ARCHITECTURAL NON TRAFFICABLE CONCRETE ROOF AREAS - EXTERNAL FINISH

Job No:	Job Name / Address	Date	Revision
2424	46 Victoria Parade, Manly	JAN 2020	A

EXTERIOR MATERIALS – Addendum 1 - Non Trafficable Roof Terrace

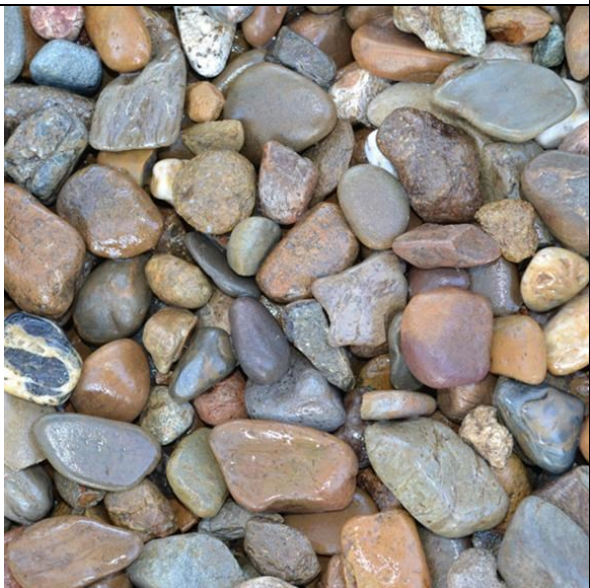
CONCRETE ROOF					
Code	Image	Location	Description	Specification	R
CR1		Level 1 – South Concrete Roof over driveway entry ramp	200mm RC suspended slab 180/180/180 with seamless Waterproof membrane covered with impact board for 60mm deep pebble ballast evenly spread. Ref drawing A002 for extent	Sandy/Brown washed river gravel. Ensure gravel size is adequate to prevent removal by birds. (30mm-40mm diameter) Australian Native Landscapes (\$106/tonne)	A
